AMENDMENT(S) TO THE DRAWINGS

REMARKS

Amendments to Specification and Drawings

Fig. 3

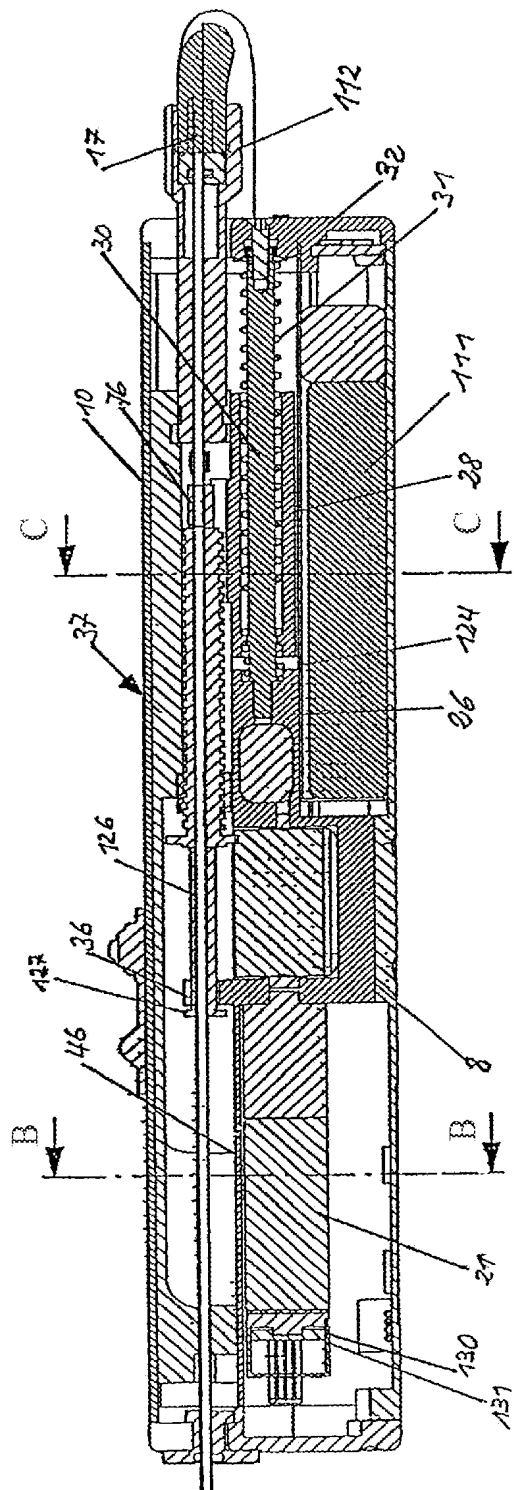
Please amend Figs. 3, 4, and 5 as indicated in red on the attached Annotated Sheet. A Replacement Sheet presenting replacement figures which incorporate the desired changes is also attached in the Submitted Drawings section of this amendment.
